**ELECTRICAL,
IGNITION AND RADIO**

ADDENDUM

CHANGE IN CATEGORY OF BULLETIN CB-4

CATEGORY 1 MODIFICATION.DYNAMO AND CURRENT VOLTAGE REGULATOR.

FIG. 1.

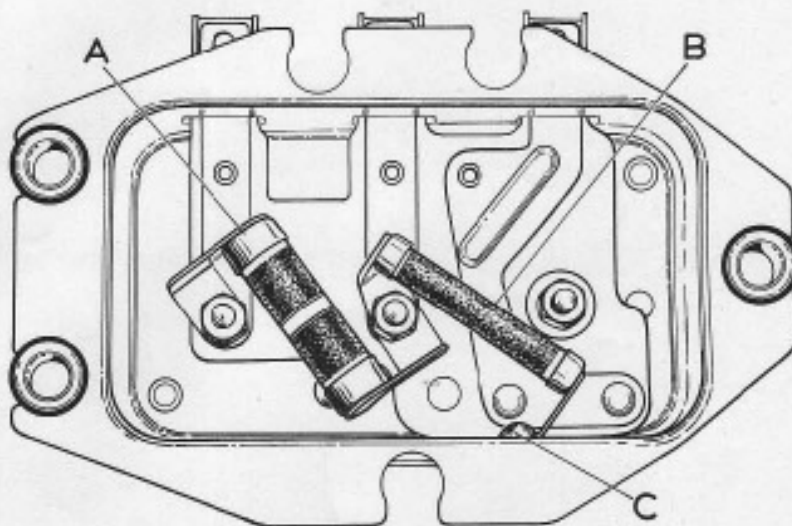
To modify a regulator stamped "M" to the "H" specification, the existing 150 Ohm resistor in the base is to be replaced with one of identical appearance but with a resistance of 63 Ohms. (A. Fig.1). Great care must obviously be taken not to confuse the two together. An additional "swamp" resistor (B. Fig.1) is to be fitted to the 2 BA terminal on the base of the centre coil assembly and soldered to earth

on the casing (C.Fig.1).

Regulators thus modified are to be marked with a yellow spot next to the letter "M" or, preferably, the letter "M" should be deleted and replaced with an "H".

FIG. 2.

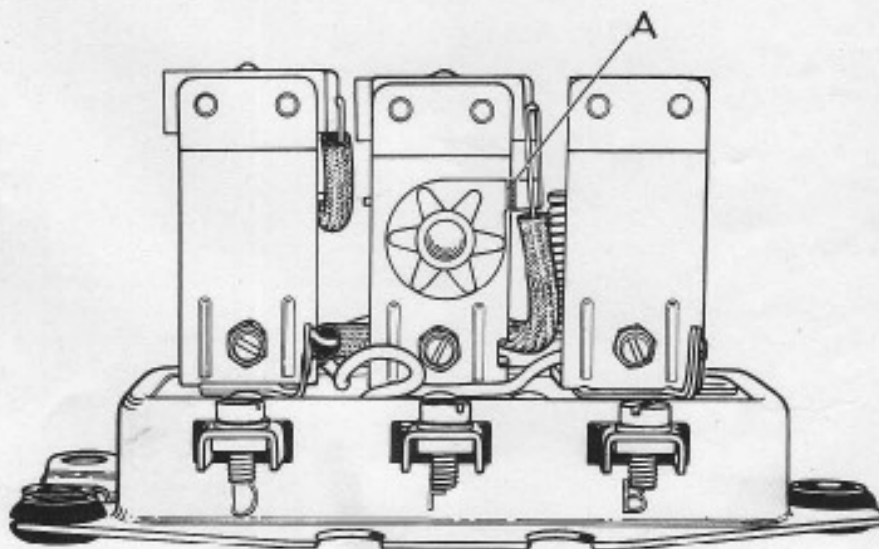
The palette resistor on the centre coil assembly is to be disconnected by cutting the connecting bridge to the coil terminal where indicated (A.Fig.2).

Horn Button and Horn Contact Assembly.

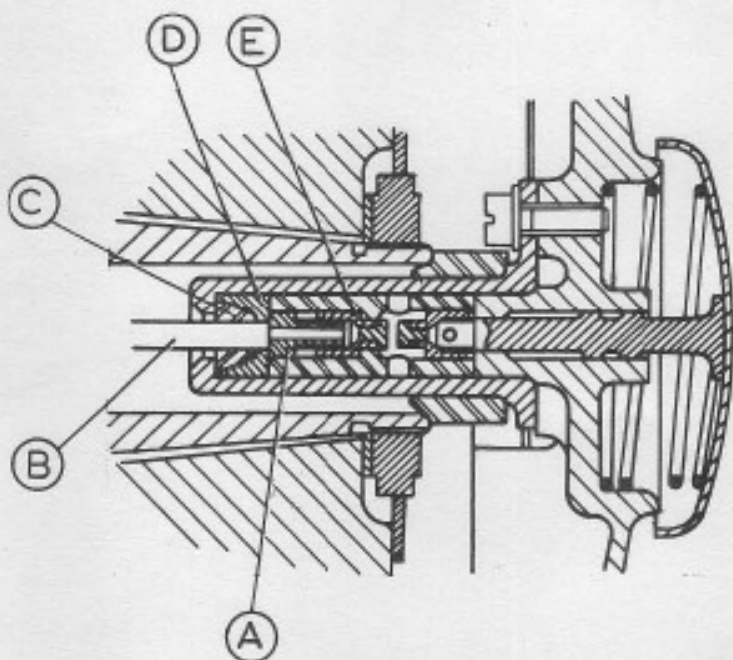
At the top of the steering column the horn cable terminal screw, into which the horn cable is soldered, moves with the steering wheel, whereas the horn cable tends to remain stationary; this action places a torsional load on the cable close to the terminal screw and may cause fatigue failure of the cable at that point.

To overcome this possibility the horn cable assembly is to be replaced with one having a cable more resistant to fatigue failure, and a horn cable bush (which fits next to the terminal screw), that will clamp the cable within the horn contact housing so that rotation of the steering wheel does not tend to twist the terminal screw relative to the cable but twists the whole cable.

Disconnect the cable from the snap connector at the base of the steering column and demount the horn button housing by removing the three retaining setscrews in the underside of the steering wheel boss. This will allow the horn button housing and the contact housing to be removed complete with cable. Remove the insulator bush and unscrew the horn cable contact point noting the number of turns taken to unscrew it, so that on re-assembly the horn contact can be screwed onto the new cable the same number of turns which will approximately give the correct horn contact gap.

Discard the existing horn cable assembly and fit the modified one, re-screwing the horn contact as mentioned previously.

Remount the whole assembly and check the horn button movement before the horn operates; this should be approximately .040" and is measured by placing feeler gauges under the rim of the horn button and noting the clearance between the under surface of the horn button and the horn button housing, then reducing the feeler gauge thickness to .040" and pressing the horn button; the horn should sound just as the feeler gauges are gripped.
